Signal Dynamics Corporation

RE: Noncompliance Notification Letter

Diamond Star Recall Kit Instructions

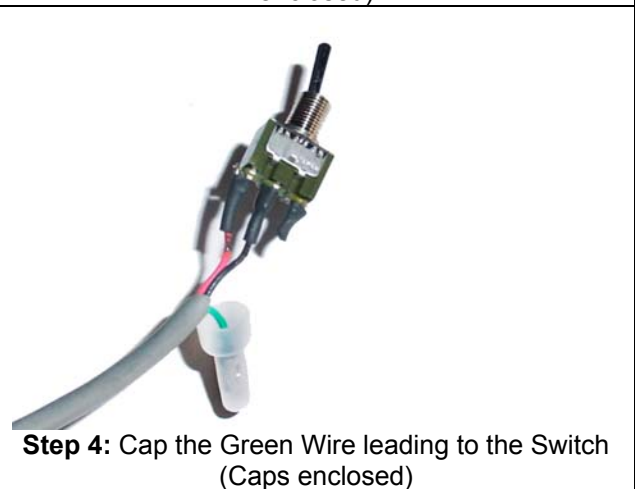
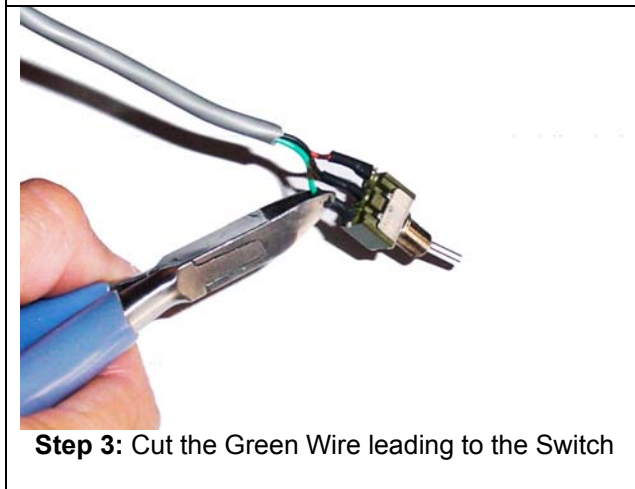
There are two conditions the user may select that would cause the module to be non-compliant.

1. If the control switch is placed in the "nova" mode during the day the headlight will modulate at 480 cycles per minute which is 200 cycles per minute above the maximum of 280 allowed by the Federal Motor Vehicle Safety Standard.
2. If the module was connected to the horn system of the bike, and the horn is pressed after dark the module will cause the headlight to modulate for 3 seconds. Per the Federal Motor Vehicle Safety Standard the headlight may not modulate after dark. This could distract oncoming traffic and may result in a vehicle crash.

Signal Dynamics will make available a kit, which will include all instructions and hardware needed to make the module compliant at no charge. In addition you may request to have the kit installed by an authorized dealer at no cost to you by calling (800) 785-1814. A copy of the instructions to make the module compliant are included with this letter.
